# CITY OF OAKLAND

### Planning Commission Design Review Committee

Subject: Proposal at 2201 Valley Street – Continued from August 8, 2018 Design Review Committee Meeting;

# 2201 Valley

at Lee Street

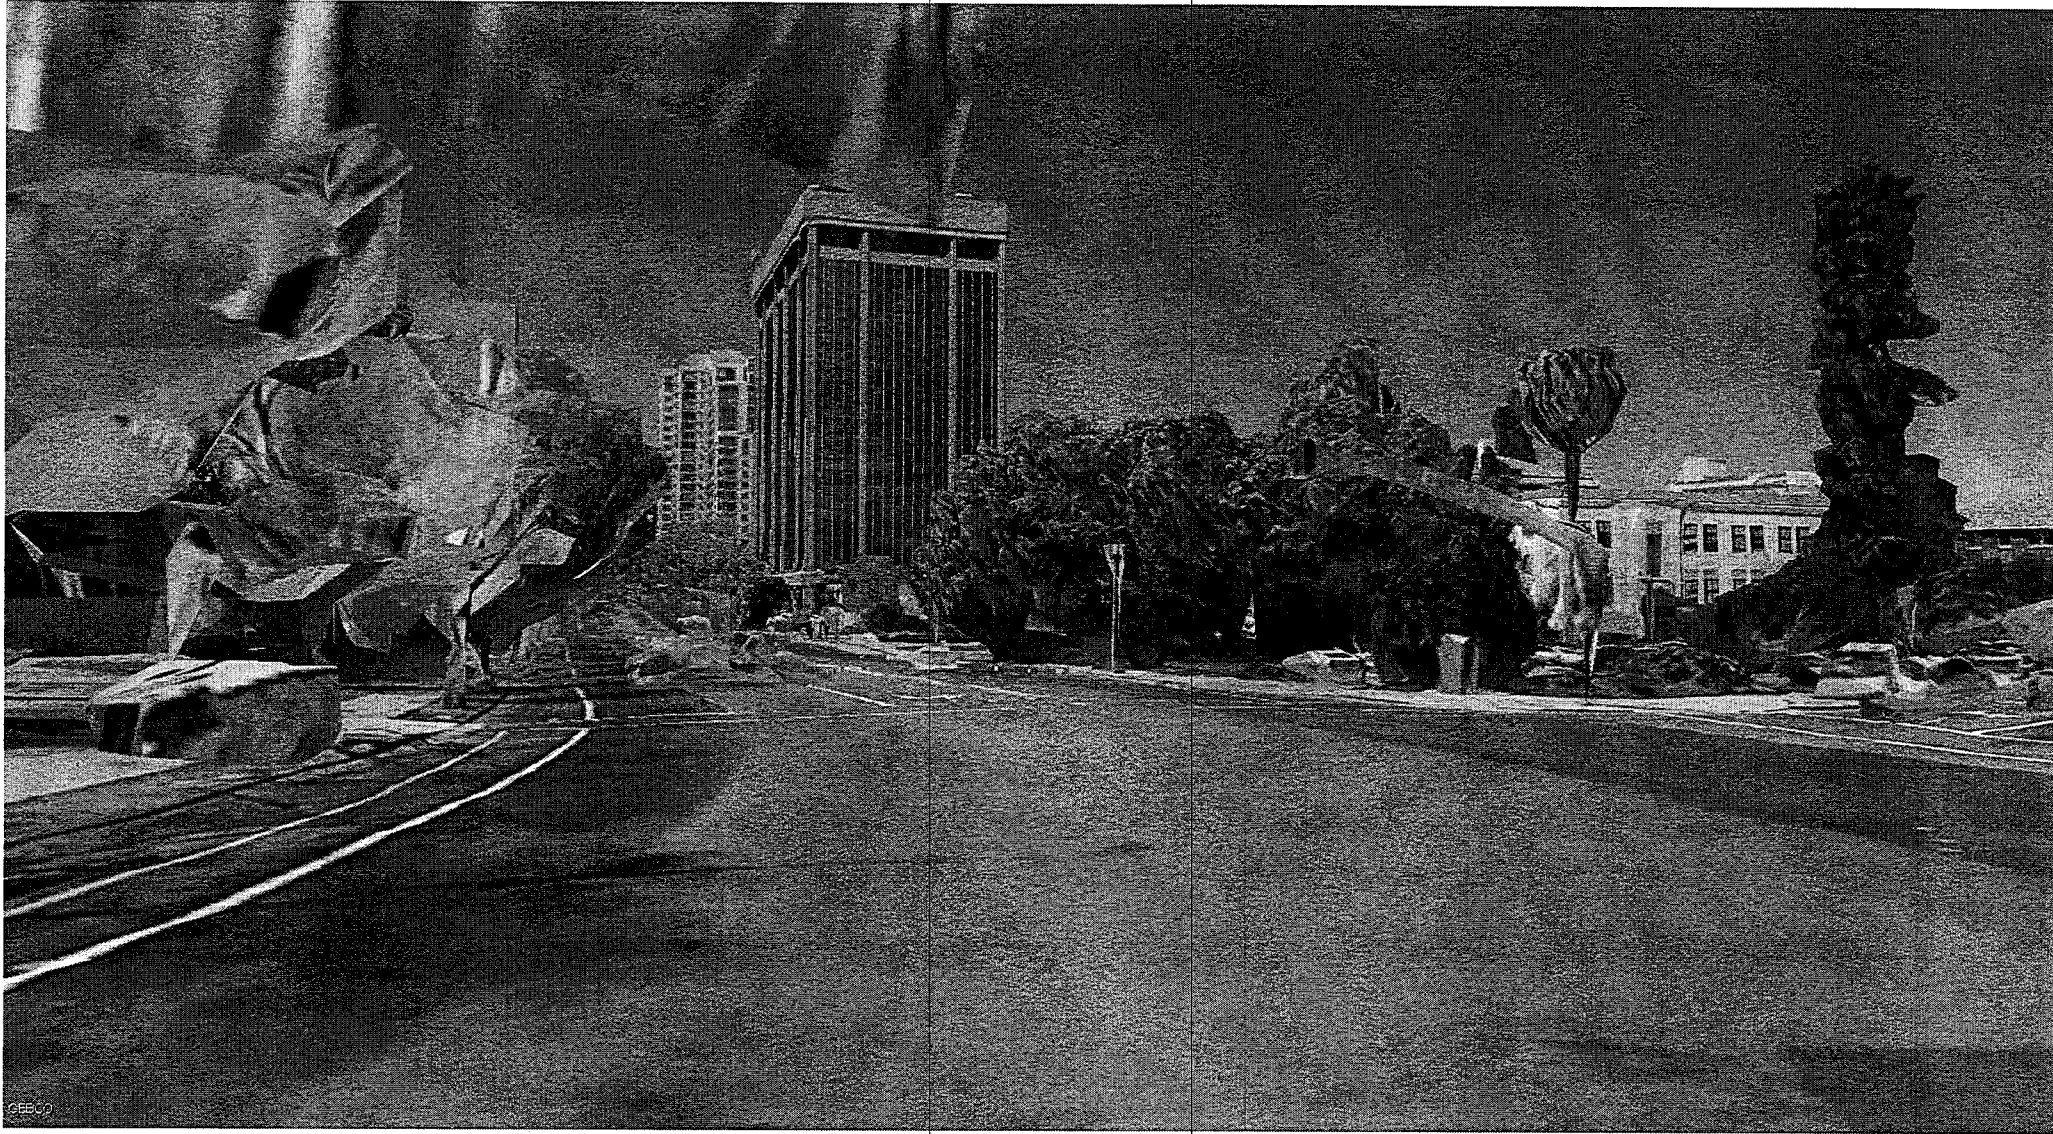
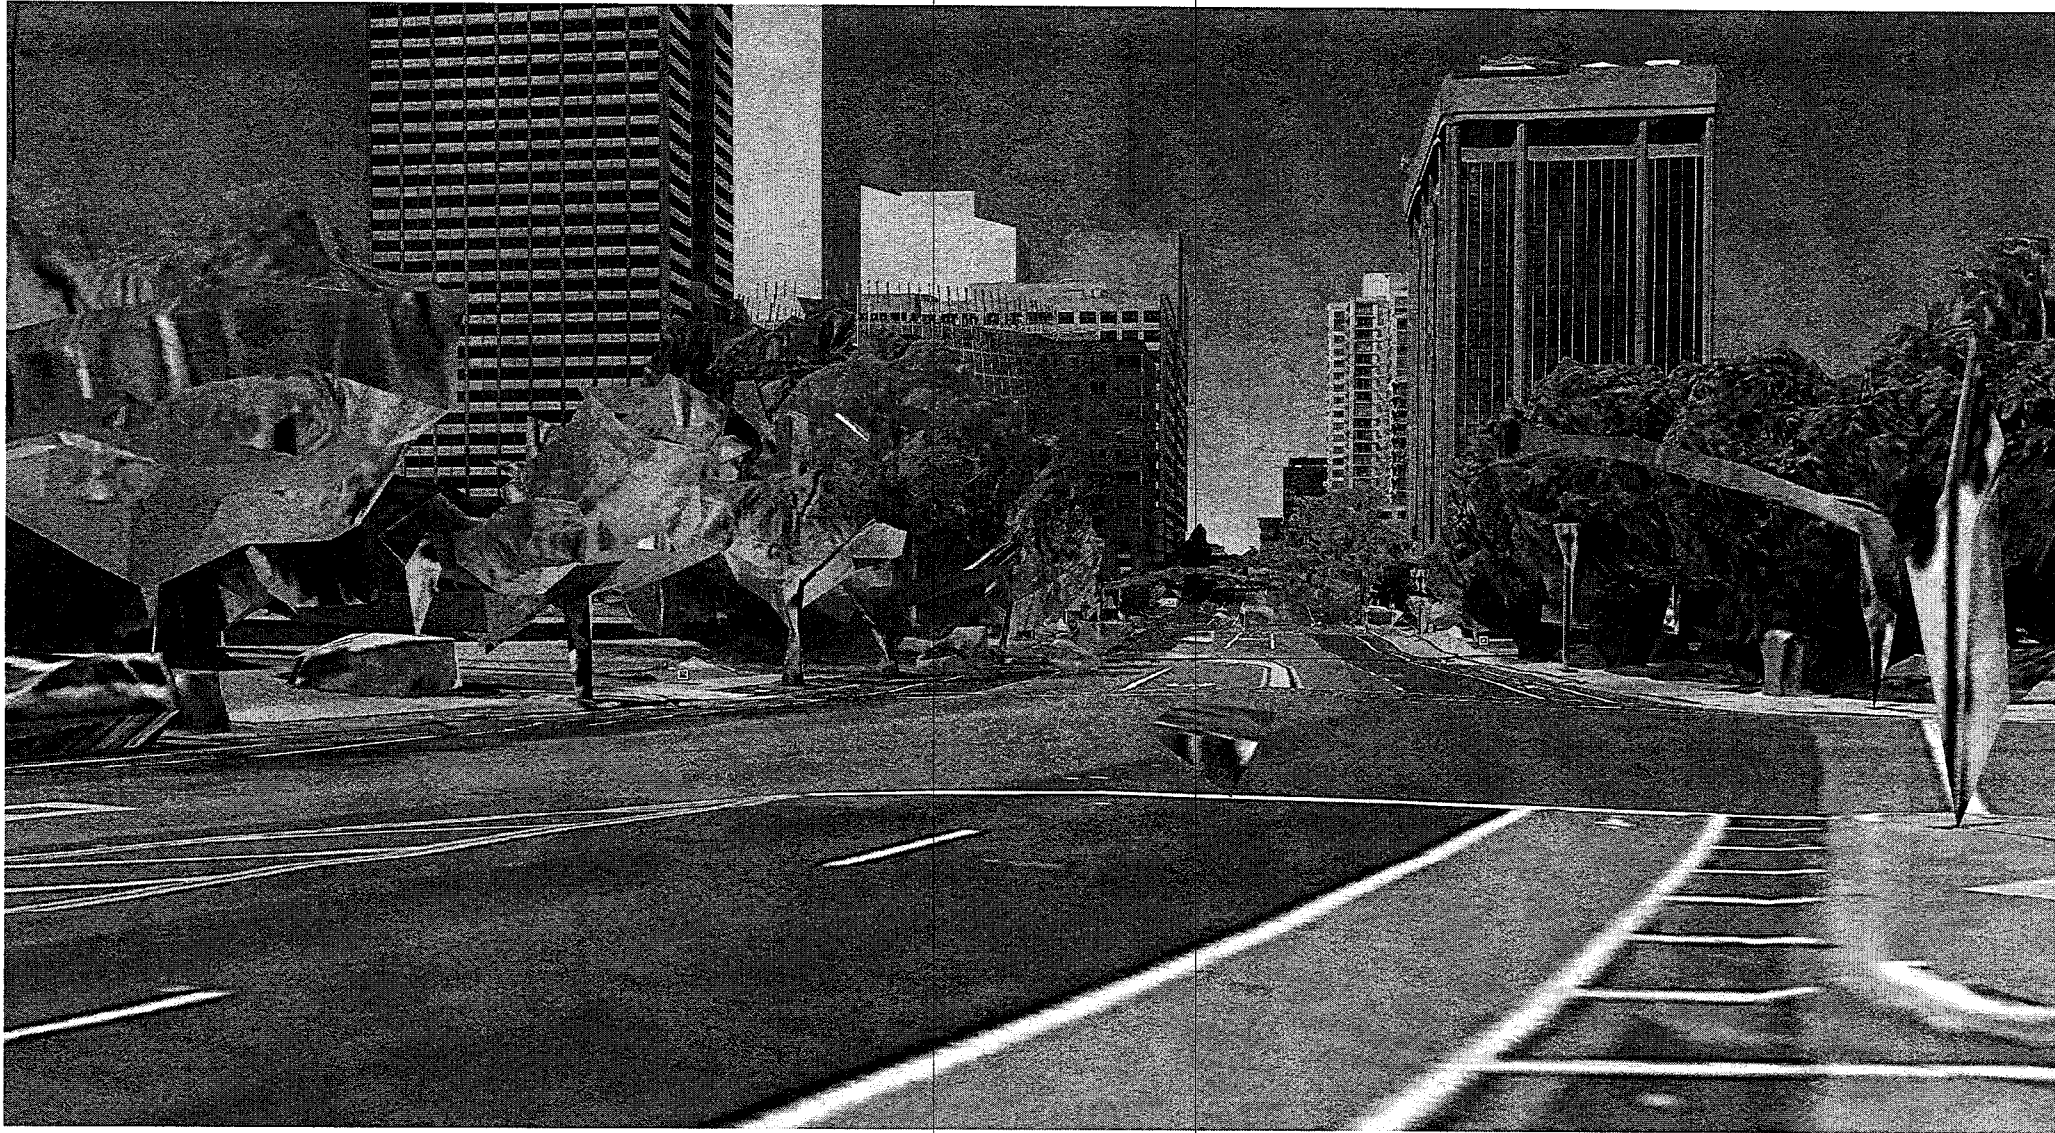
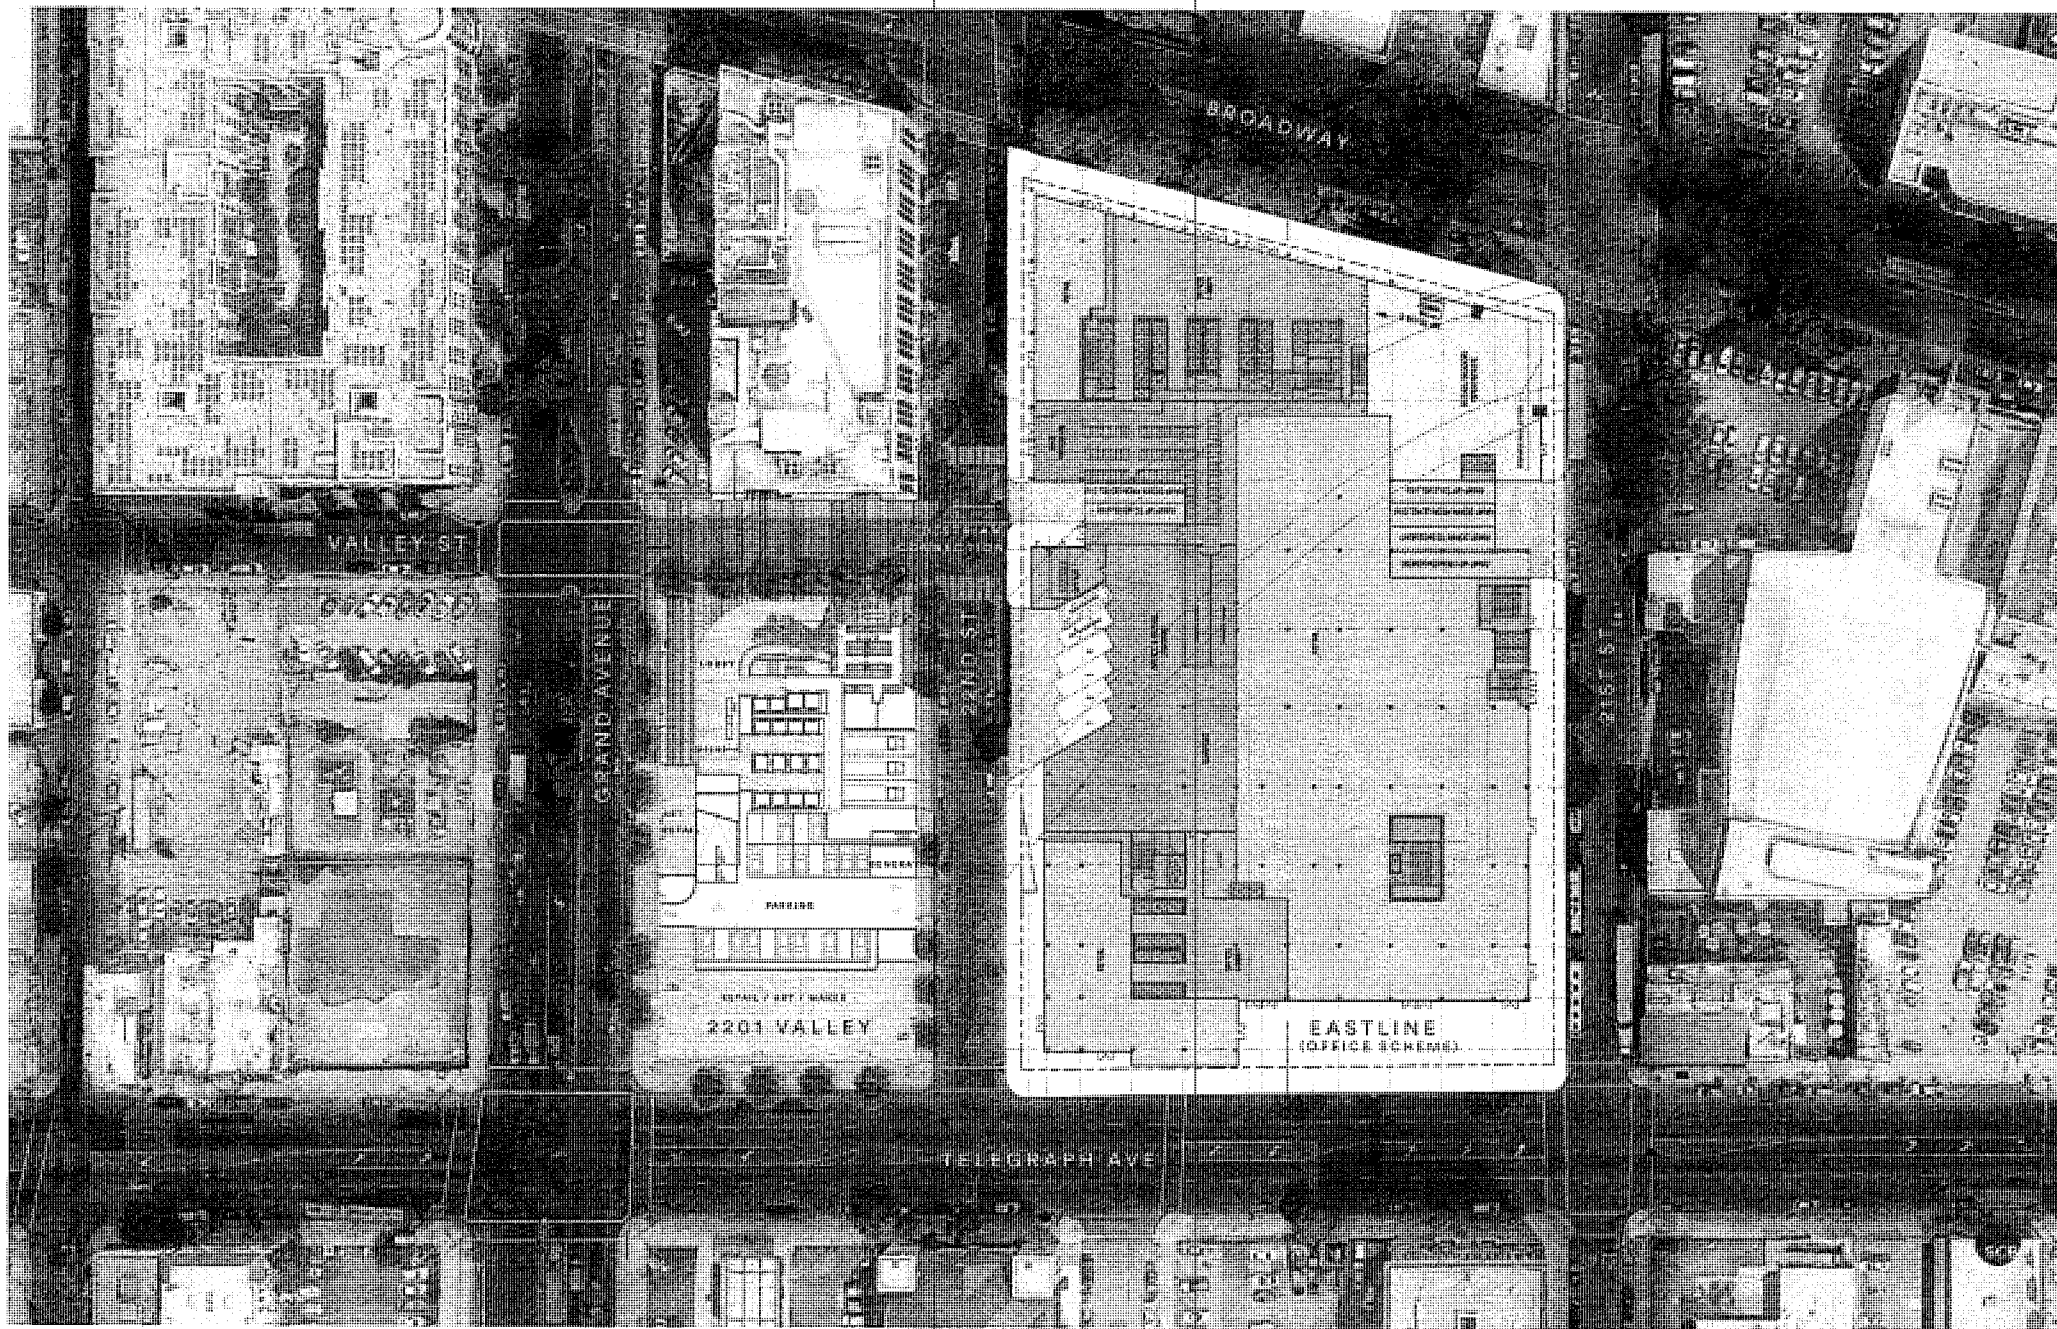
At the prior meeting comments were made about the compatibility of the proposal within the context of the surrounding area as well as the overall skyline view from a distance. The applicant has provided additional images in the plan submittal for consideration and comment.

PARKING SCREEN

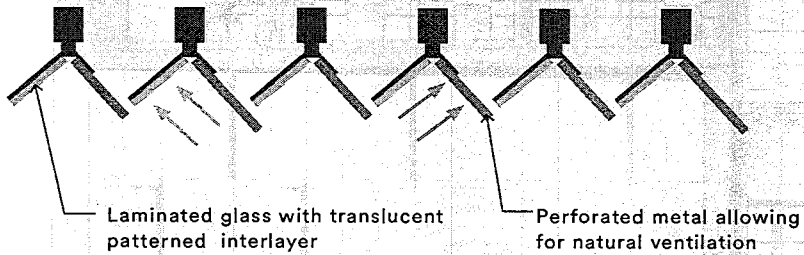
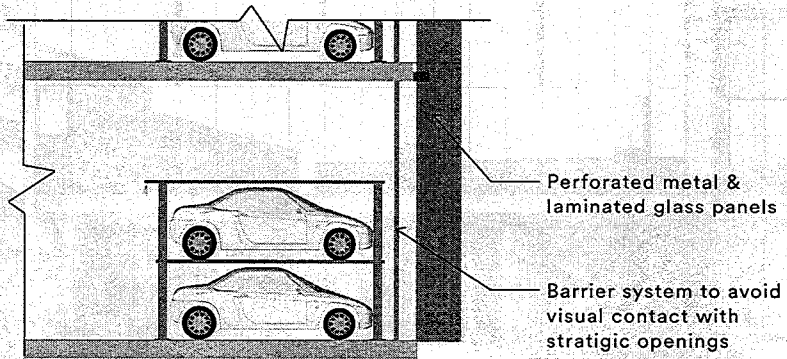
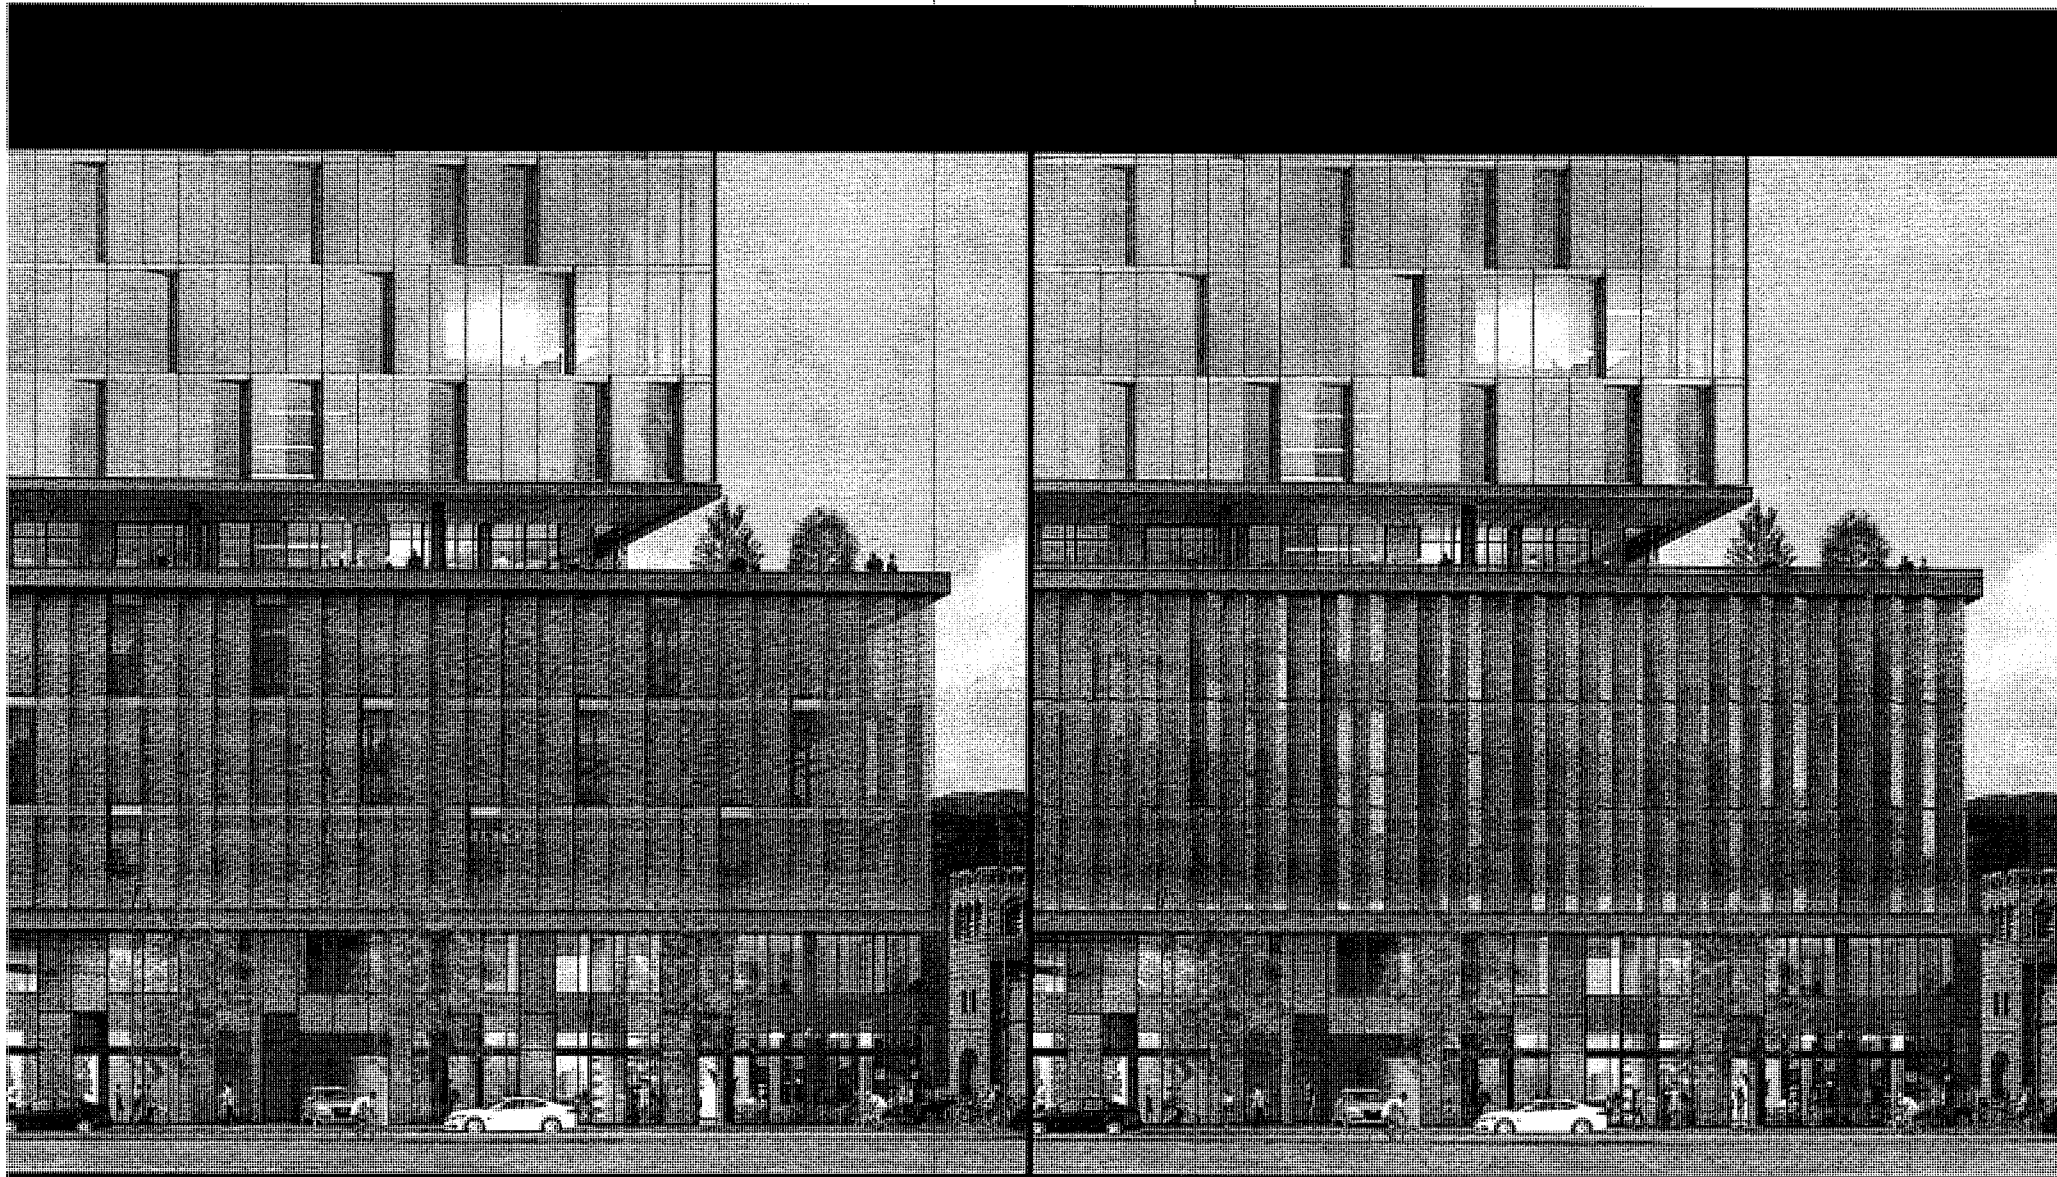
The proposed project includes three full parking garage levels above the ground floor, which is proposed to be screened by a perforated metal cladding system along the Telegraph side of the building, and further screened by a glass curtain wall system along the Valley Street side of the project. Staff had raised concerns about the location of the screening for garage ventilation and had recommended that more of the open screening be located off the main street facades. The applicant has submitted revisions that refine the screening on the garage to demonstrate how the proposal would be able to screen vehicles from view from the exterior of the building and are proposing to incorporate a public art component into the screening area. Staff requests that the DRC review and comment on this approach, and would also recommend that if this approach is accepted that the public art component be completely defined prior to consideration by the Planning Commission.

**WE HEARD :** Eliminate view of cars; celebrate the screenwall design along Grand and Telegraph elevations.

**WE ADDED :** Parking screen relationship to the crown screen.

- \* Eliminate visibility of the cars
- \* Artistic expression on the panel screens
- \* Angled panels giving texture and rythm while ties to the tower above and the crown
- \* 50% natural ventilation
